#### NEEDHAM PLANNING BOARD

#### <u>Tuesday November 2, 2021</u> 7:15 p.m.

7:20 p.m. Amendment to Major Project Site Plan Special Permit No. 2009-06: Town of Needham, 1471

7:45 p.m. Major Project Site Plan: Needham Enterprises, LLC, 105 Chestnut Street, Suite 28, Needham,

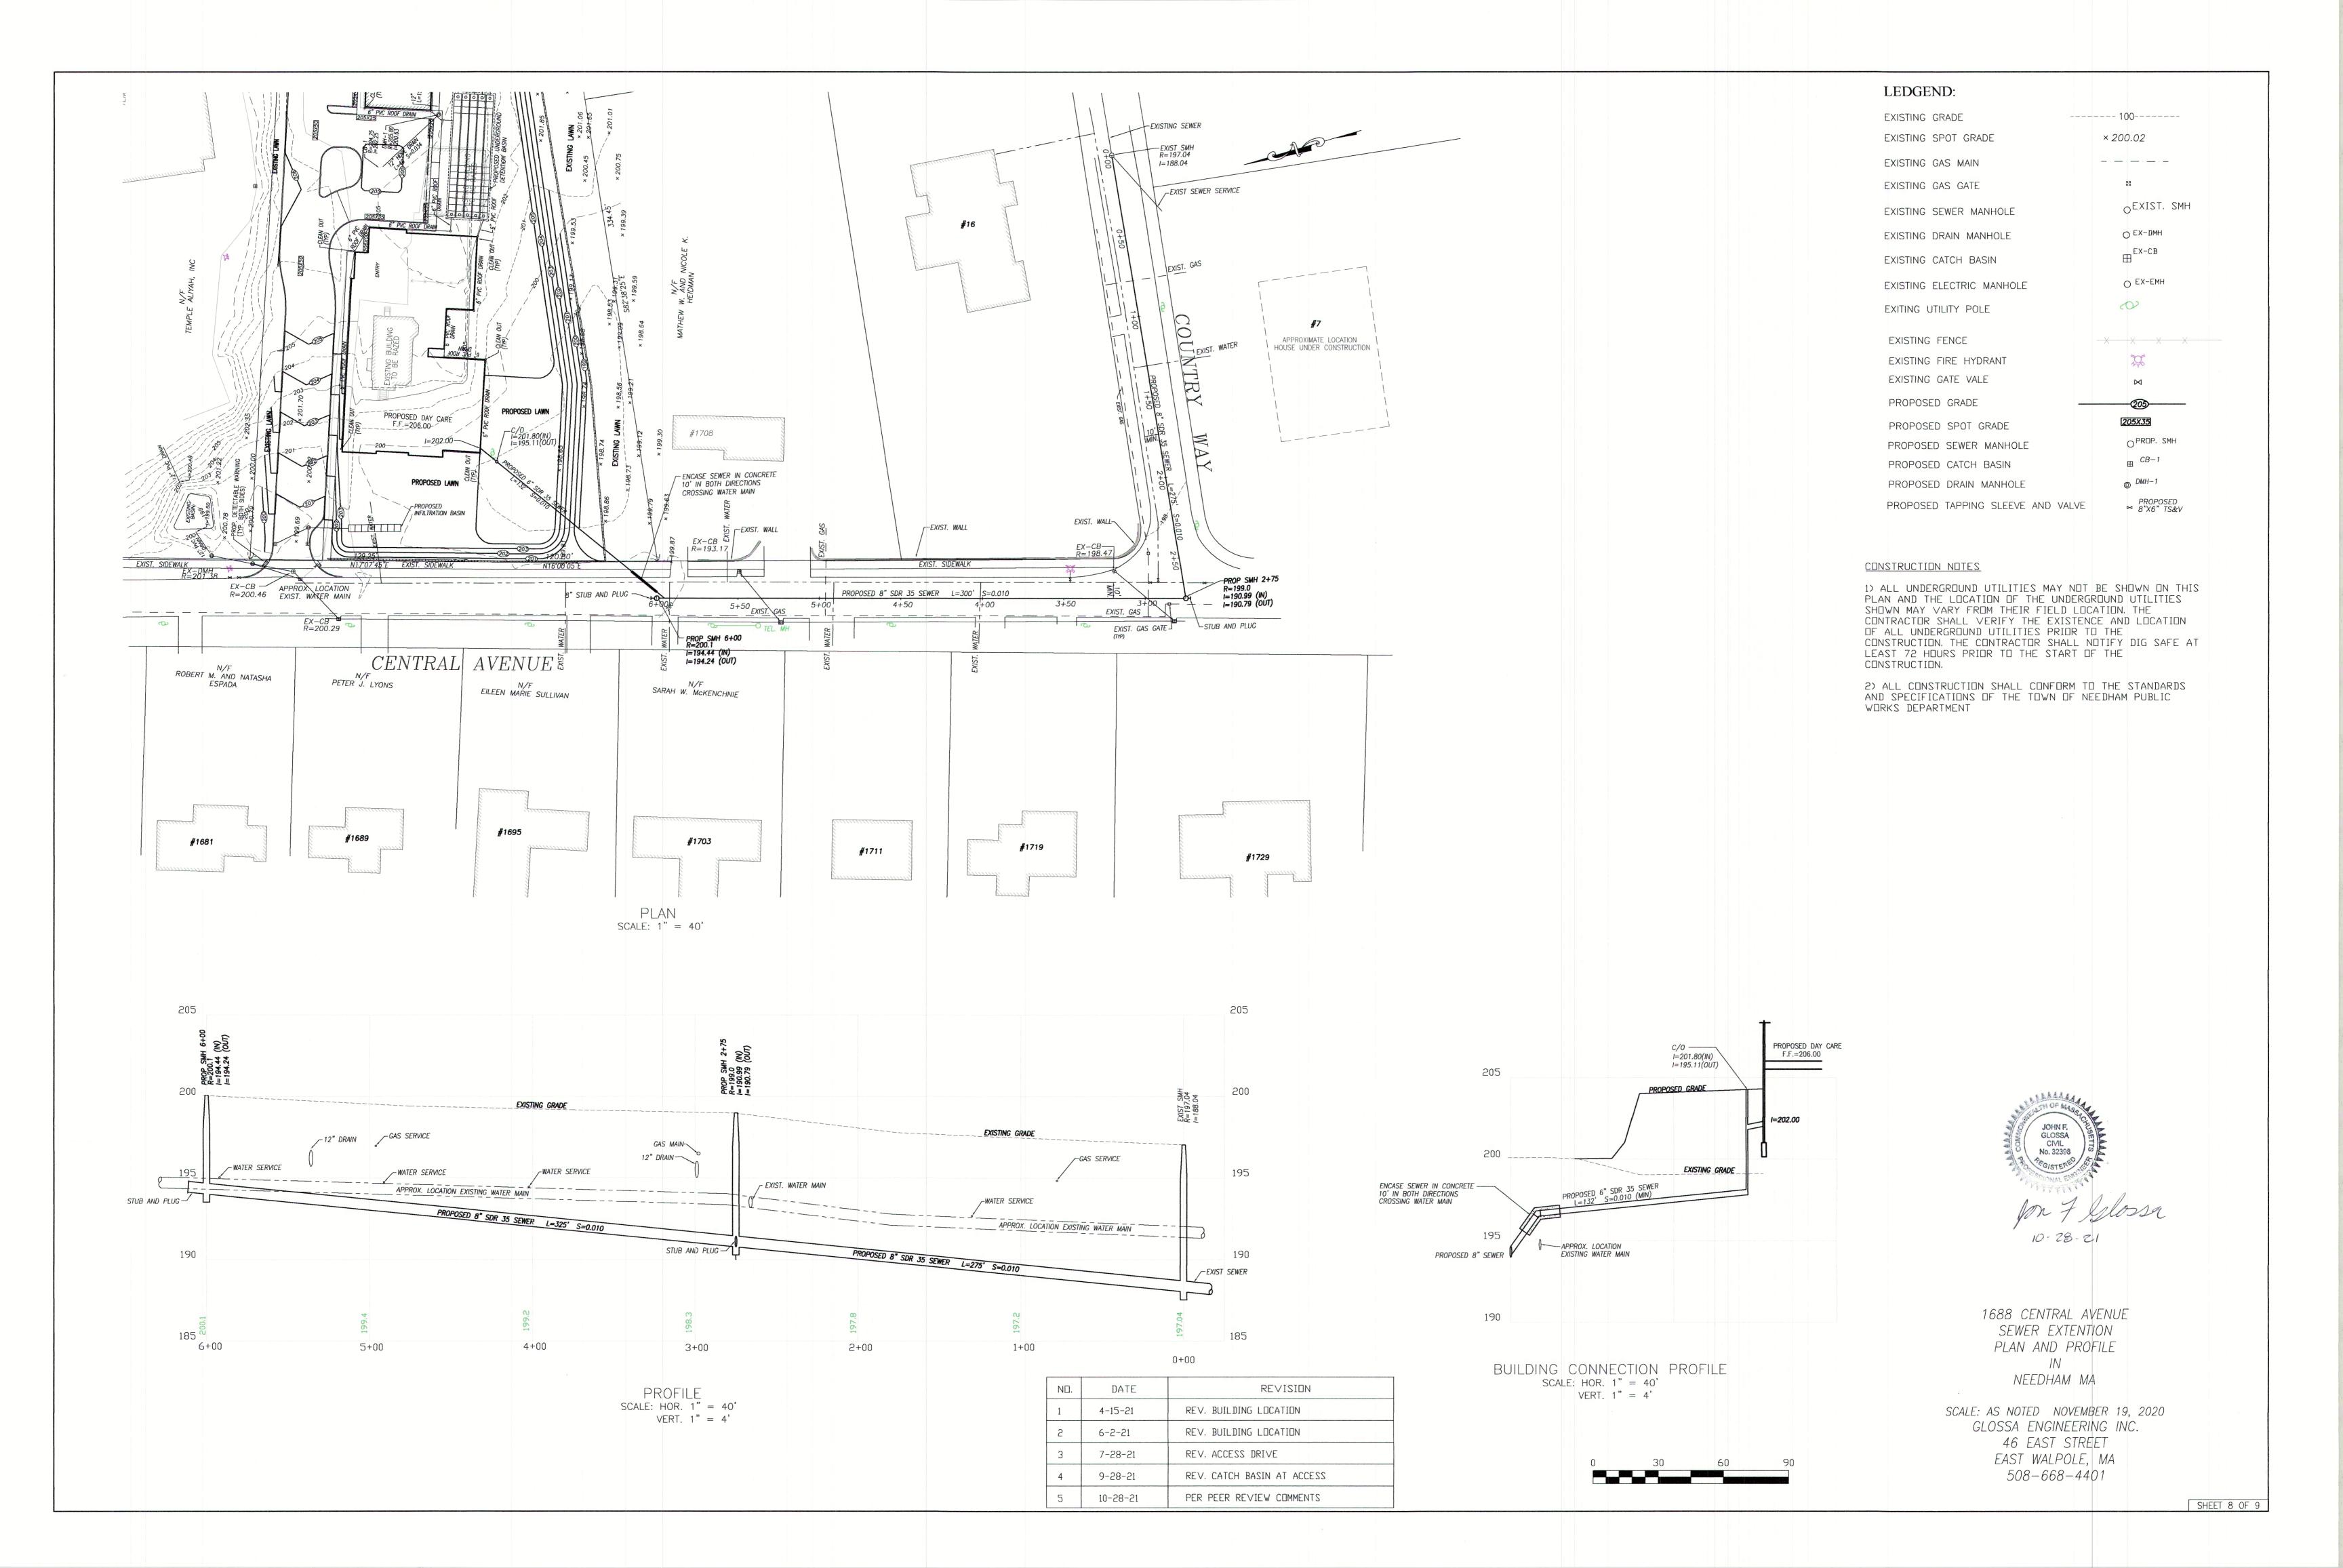
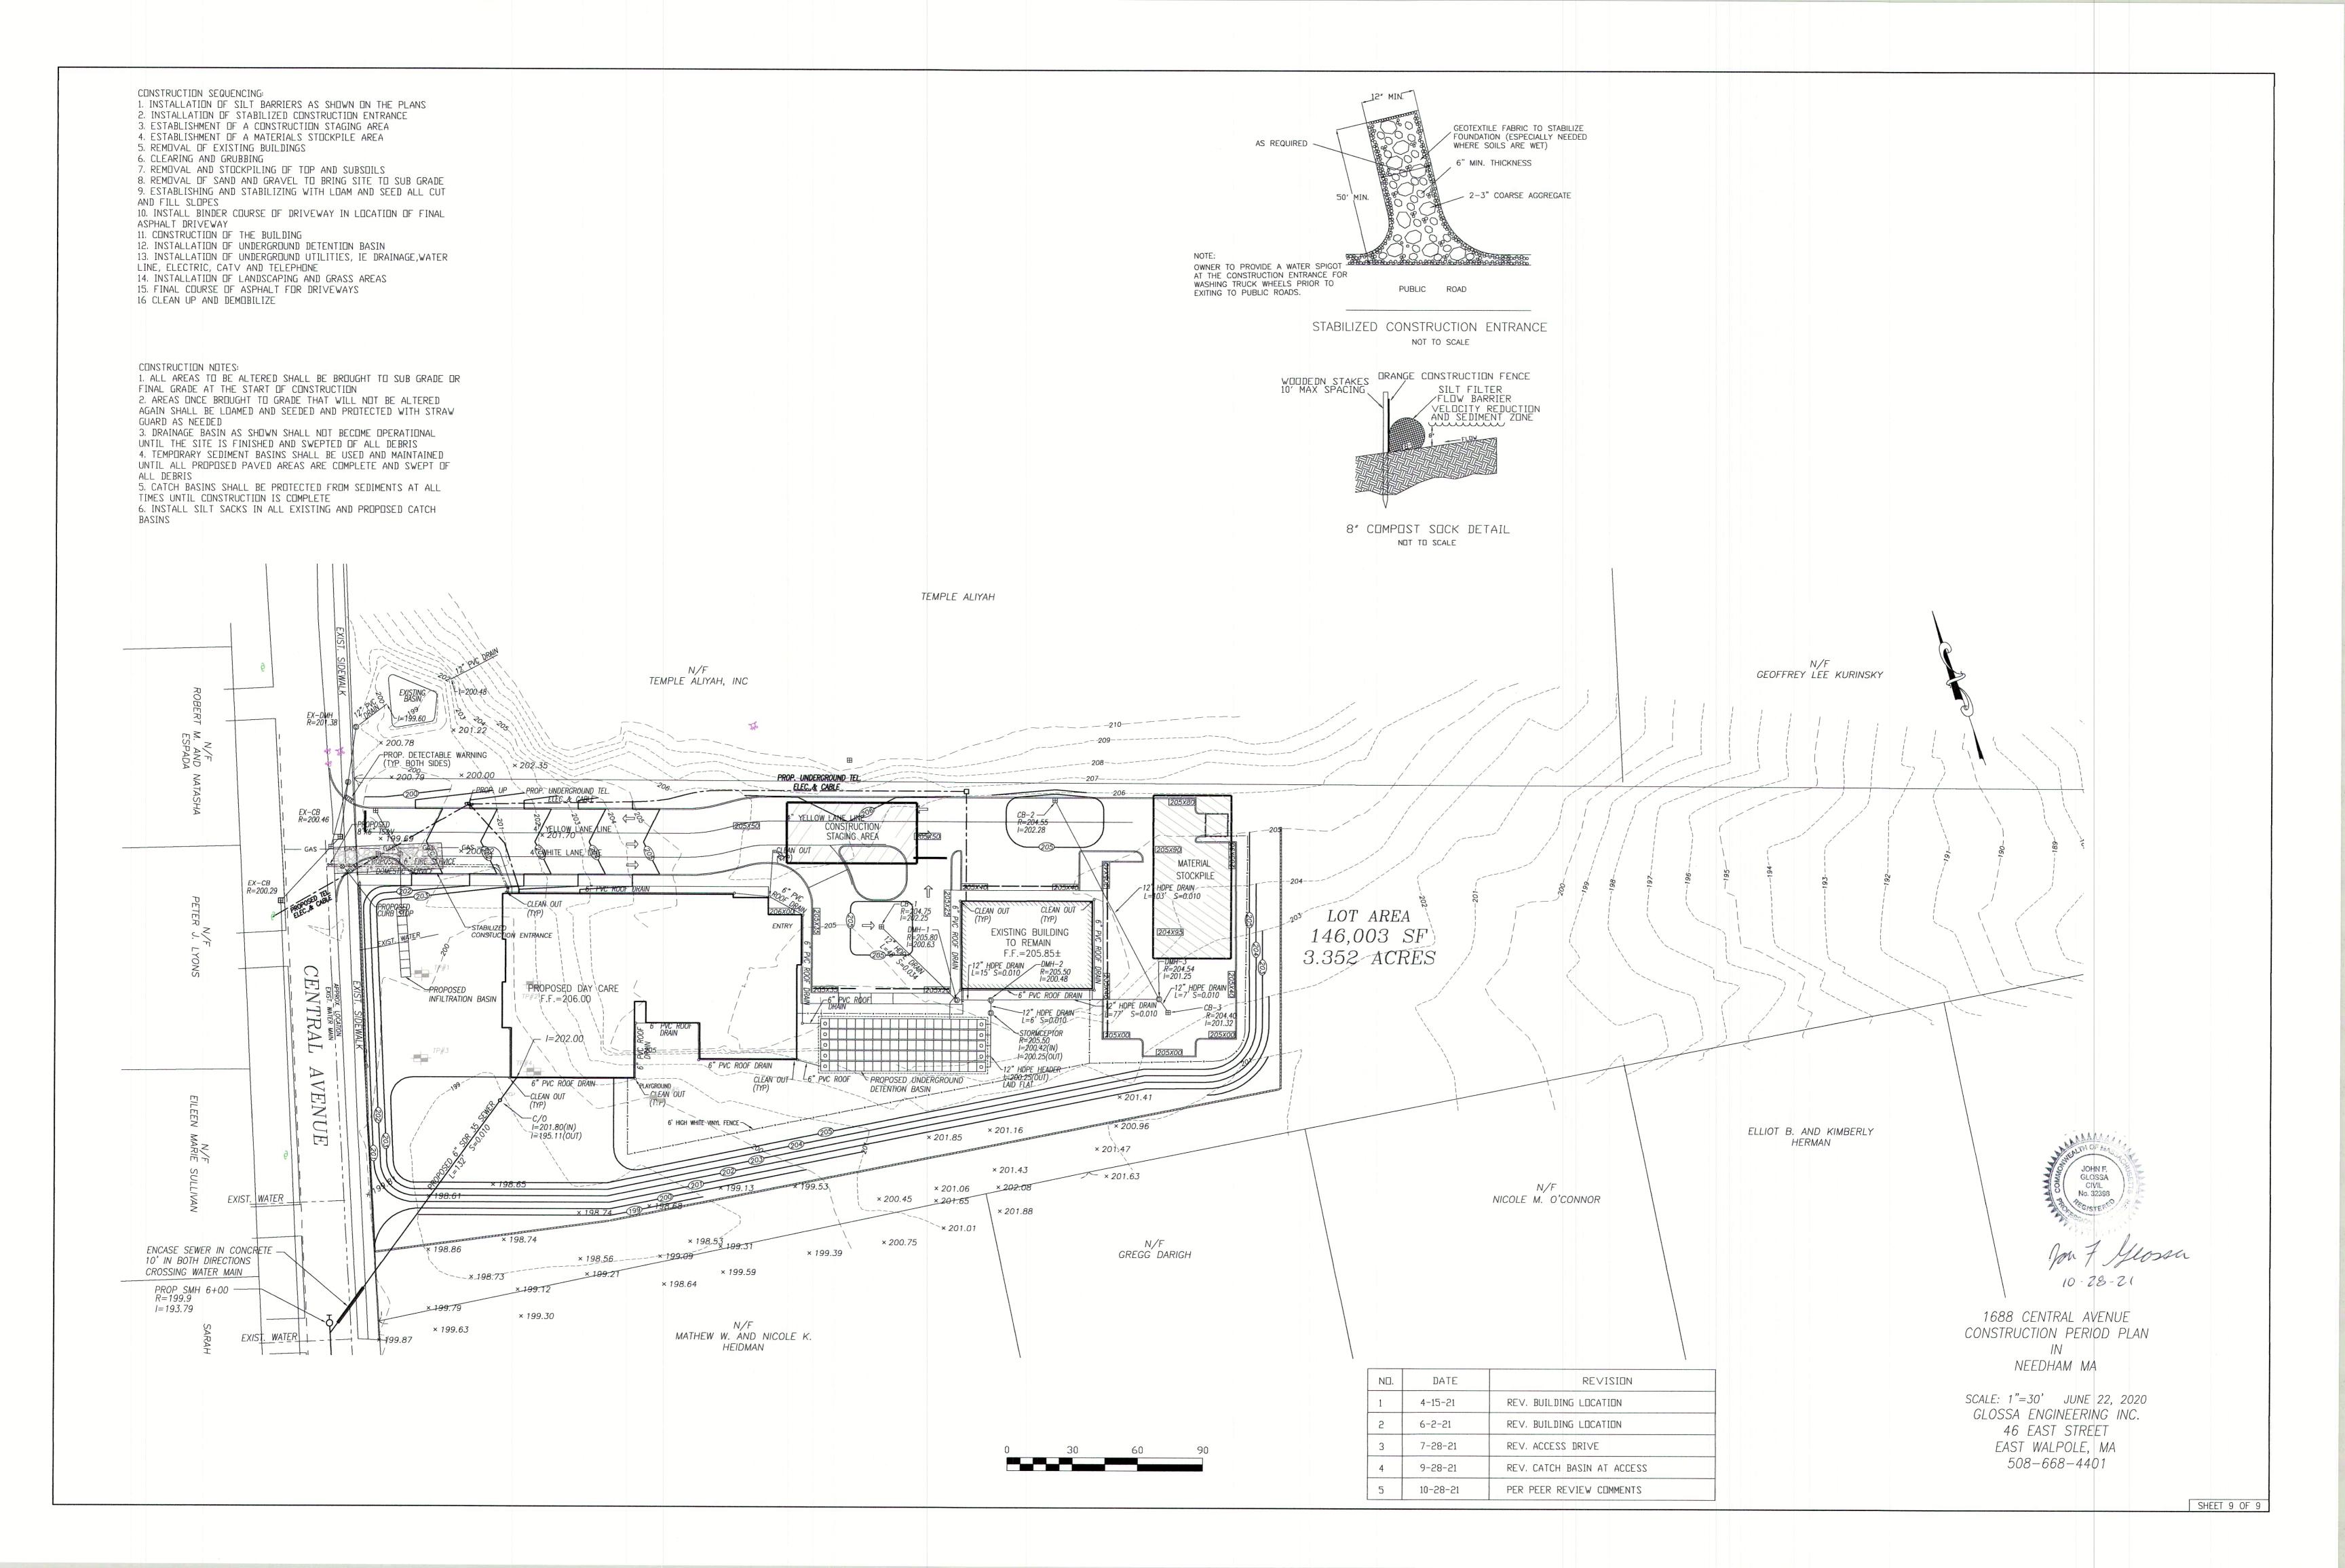
a) Sheet 4 - Proposed grades of the centerline of the driveway apron do not make sense. It appears to slope DOWN from the edge of road to the front of crosswalk by more than 2% and then slope up to the back of the crosswalk by more than 4%

- b) <u>Sheet 4 The spot grades 200x68 and 200x74 indicate the apron slope of about 1% UP at the sidewalk openings and a 1.8%-2.0% slope across the sidewalk/crosswalk, the apron portion should be sloped greater than the crosswalk portion.</u>
- c) <u>Provide grades on sidewalk approaching driveway. It is unclear if the sidewalk slopes to</u> the driveway or is level with the crossing.
- d) Sheet 4 Limit of work on the sidewalks should be indicated (also relates to Comment 2)
- e) Sheet 6 Detail should be provided for the proposed driveway apron.
- f) Sheet 8 & 9 Proposed CBs should be labeled and Existing CB to be removed should be labeled
- g) Sheet 10 Either delete labels on CBs (not relevant for lighting) or correctly label the Existing CB to be Removed
